November 20, 2014

Subject: Review of Draft EIR
Walt Ranch Project, Napa, CA

FIGURE 1: County designated MST groundwater basin (Source: Napa County Groundwater Ordinance).

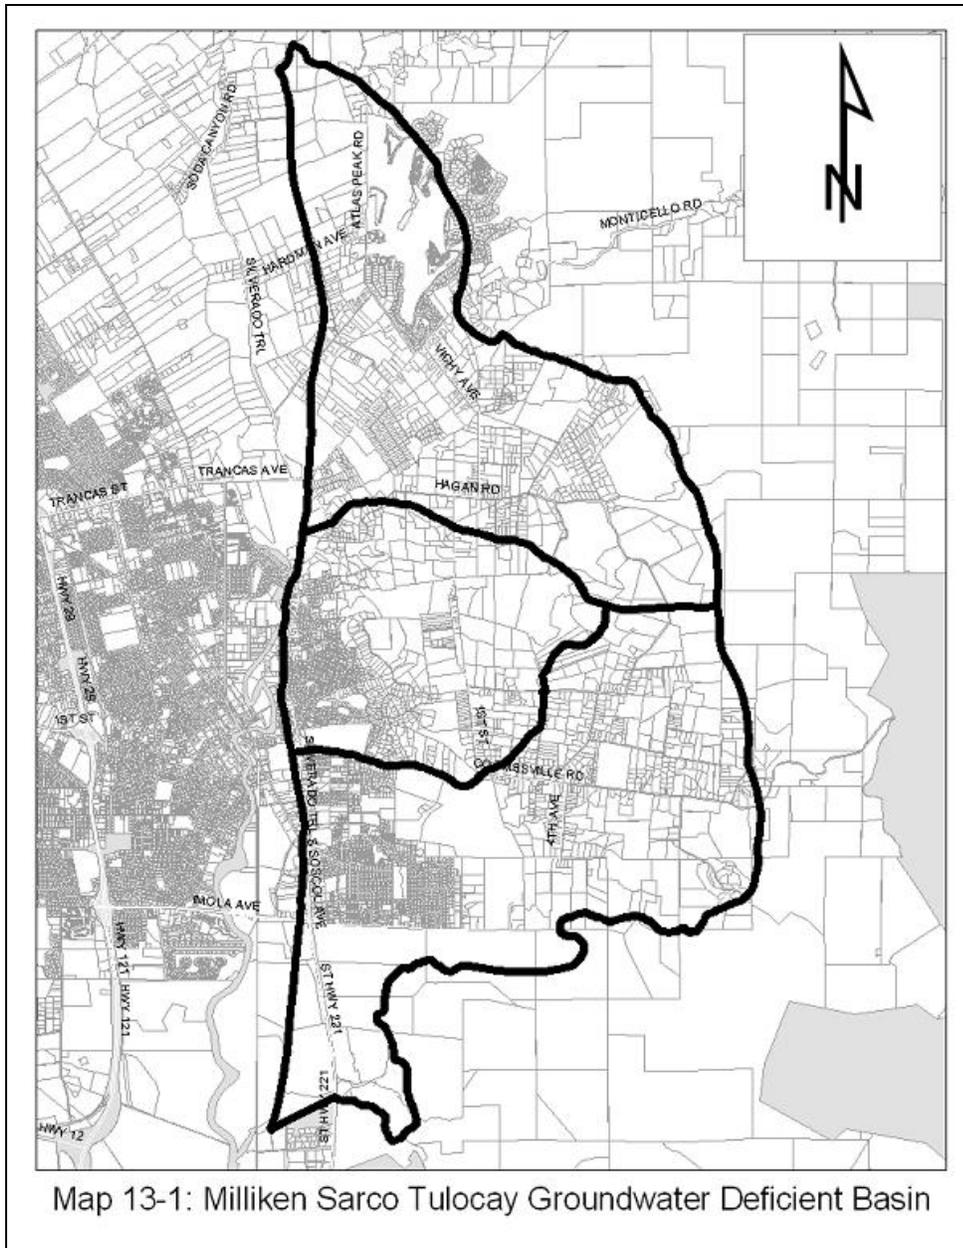
The County appears to delineate the MST basin as indicated in Figure 1 (Napa County Ordinance No. 1294, Chapter 13.15 Groundwater Conservation). The County’s MST delineation likely comes from the “Study Area” designation presented in the 1977 USGS report (Johnson, 1977) cited in the WAA. The “Study Area” outlined in 1977 USGS report defines the downstream alluvial aquifer and underlying Sonoma Volcanic groundwater storage areas associated with known groundwater overdraft. This “Study Area” encompasses a 15-square mile area within the cumulative 42-square mile drainage area for the Milliken, Sarco and Tulucaý Creek watersheds (see Figure 2). However, here is where policy and science diverge with respect to defining a groundwater basin.

In my opinion, the County has incorrectly drawn the boundary for the MST basin. To fully satisfy the intent of the fair share policy in the MST, the County needs to consider and incorporate the entire hydrologic basin, not just a portion that happens to be where water is stored and over-pumped. Perhaps a surface water analogy would better articulate this point. For example, if a community is experiencing a drought and a governing entity is charged with protecting and fairly managing the resource, one management strategy would be to set minimum withdrawal volumes for property owners around the reservoir. The “safe yield” and “fair share” intent of this policy assumed only those lake-front residents would be removing water from the reservoir. However, the governing entity then allows properties on the streams tributary to the reservoir to draw water out of the river at a higher rate/volume than the residents on the reservoir. Such a management strategy defeats the purpose of protecting the limited water resources and

allocating those resources equally among all users. The main point here is that the County's resource management policy in the MST is tied to an arbitrary socioeconomic basin boundary, not a scientifically based, watershed scale boundary.

FIGURE 2: Location of 2003 USGS study area, differentiating between basin drainage area and “Study Area” boundaries (Source: Figure 1 in Farrar and Metzger, 2003).

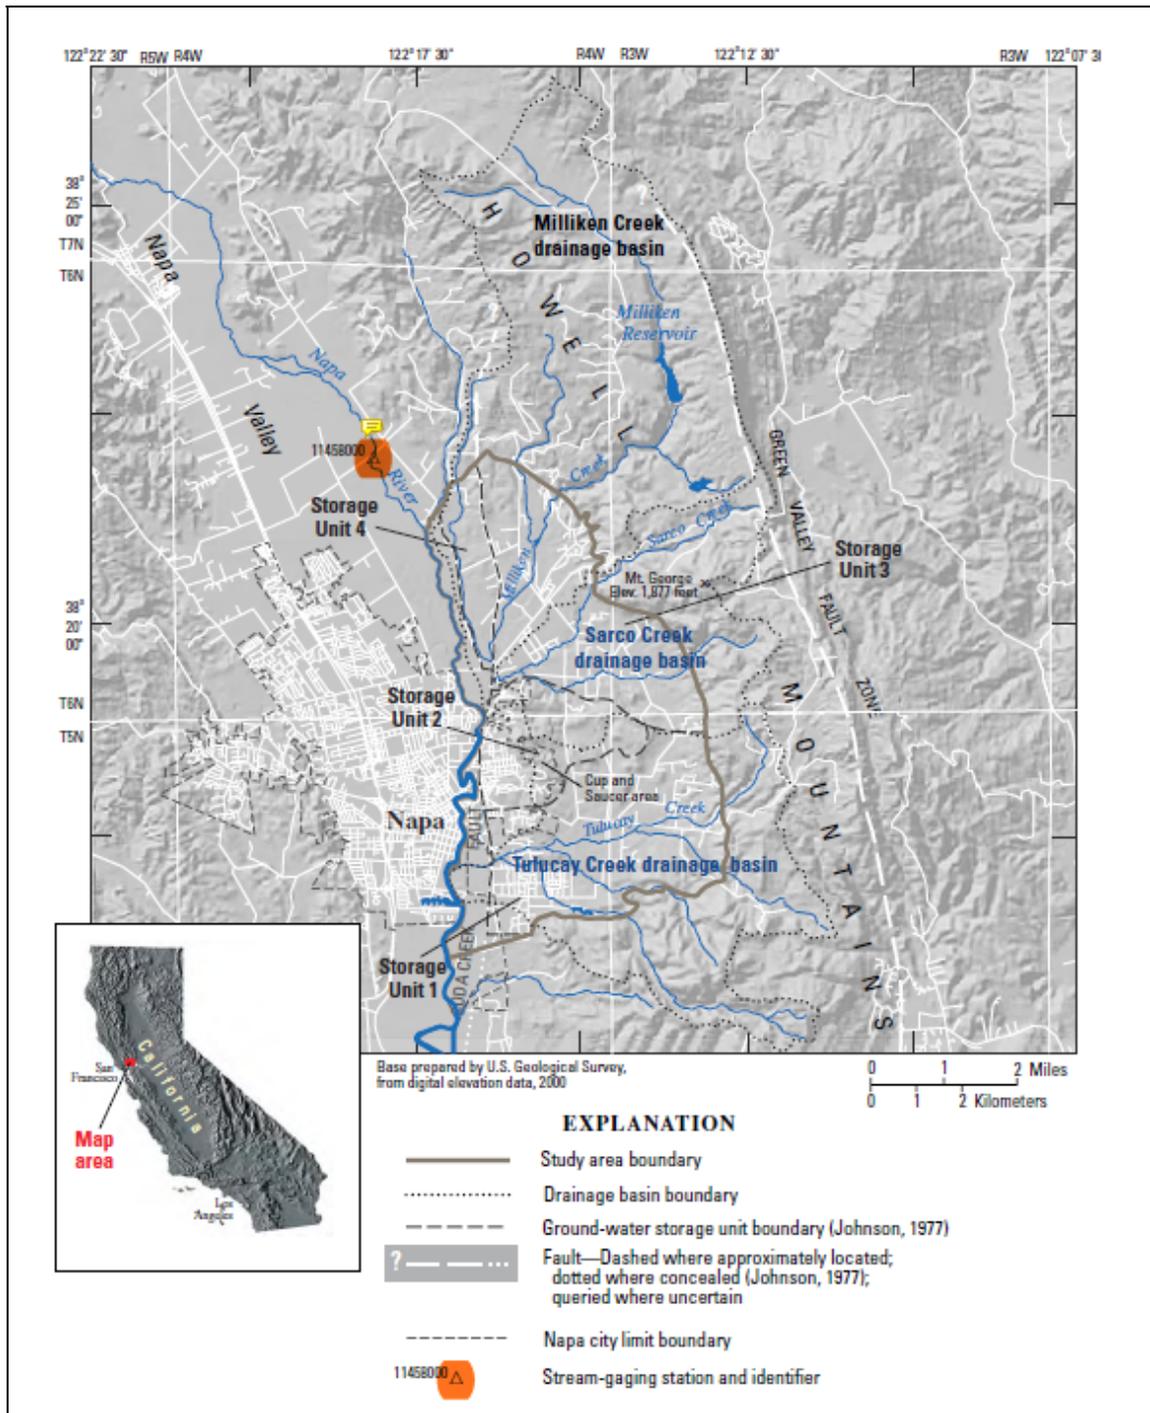
The 1977 USGS study, along with the more recent follow-up study completed by the USGS (Farrar and Metzger, 2003) clearly indicate that the 27-square mile higher elevation bedrock area lying to the east (and including a portion of the Walt Ranch Project area) are in direct hydraulic connection with and provide recharge to the 15-square mile MST groundwater storage “Study Area.” The DEIR claims there is no hydraulic connection between the Walt Ranch project site and the MST “Study Area”/groundwater storage area. The USGS (2013) provides a graphical representation of the groundwater system underling the MST Creeks watershed, reproduced here in Figure 3. This conceptual groundwater flow model indicates that rainfall infiltrates and recharges the Sonoma Volcanic bedrock groundwater in the Howell Mountain uplands. The groundwater in the Sonoma Volcanic bedrock then migrates eastward over time towards the main alluvium and deeper Sonoma Volcanics storage area in the valley bottom, adjacent to the Napa River. The eastern boundary of the County’s designated MST basin generally occurs where the foot of the Howell Mountains intersect the valley floor. The 2003 USGS report (Farrar and Metzger, 2003) provide the following statements regarding groundwater recharge to the MST.

FIGURE 3: Conceptual model of groundwater flow system in the lower Milliken-Sarco-Tuluca Creek area (Source: Figure 9 in Farrar and Metzger, 2003).

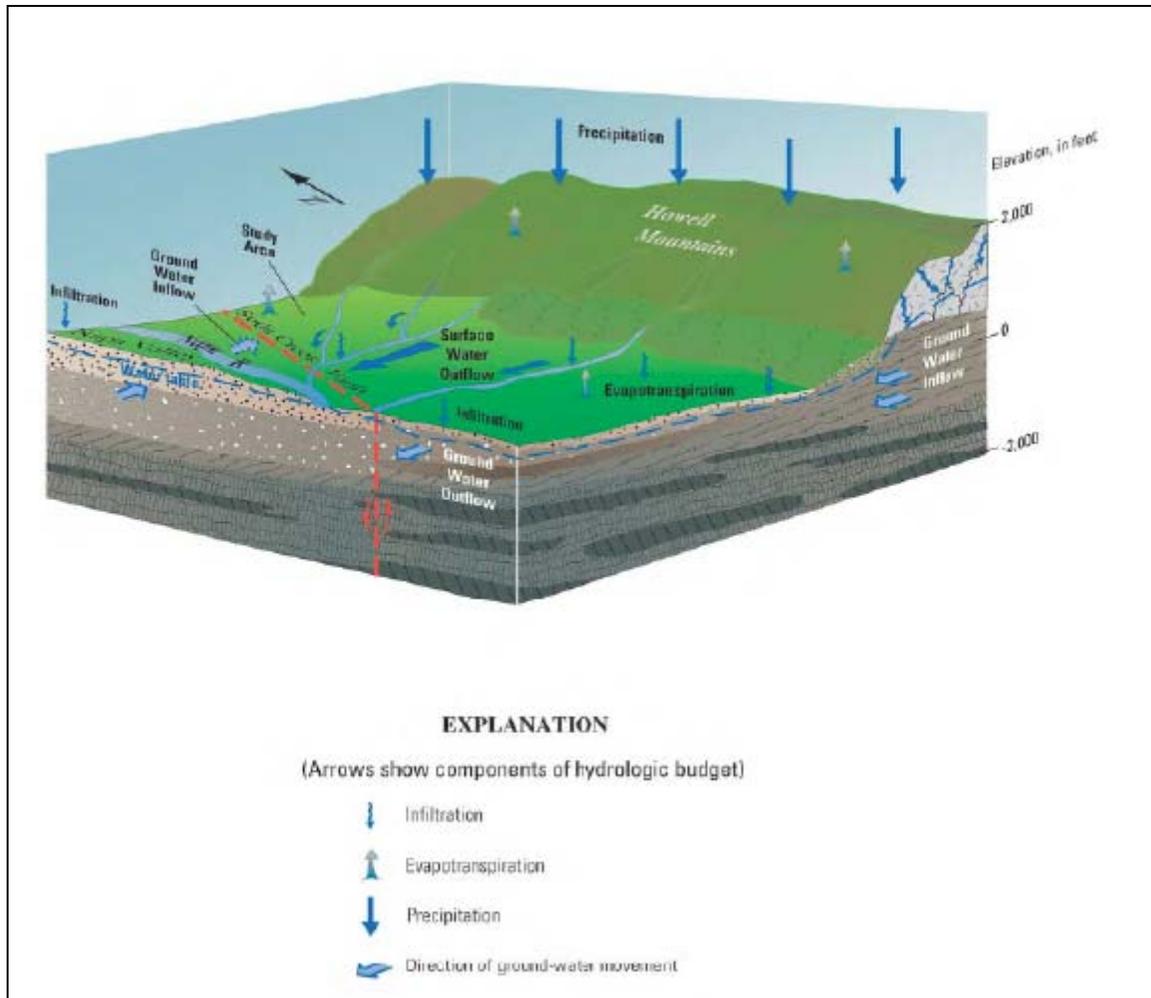
I believe that the 1977 and 2003 USGS studies provide conclusive information that that the project area lies in an important recharge area to the MST groundwater basin and a part of the Walt Ranch project site is hydraulically connected to the lower MST groundwater storage area. Further, based on Johnson’s work in 1977, groundwater inflow from the Howell Mountain uplands provides around 39% (2,100 AF/yr) of average annual recharge to the Lower “Study Area” aquifer storage unit regulated by County Codes. Thus, any withdrawals from the Sonoma Volcanics within the Walt Project site will directly reduce the groundwater inflow and supply to the MST basin.
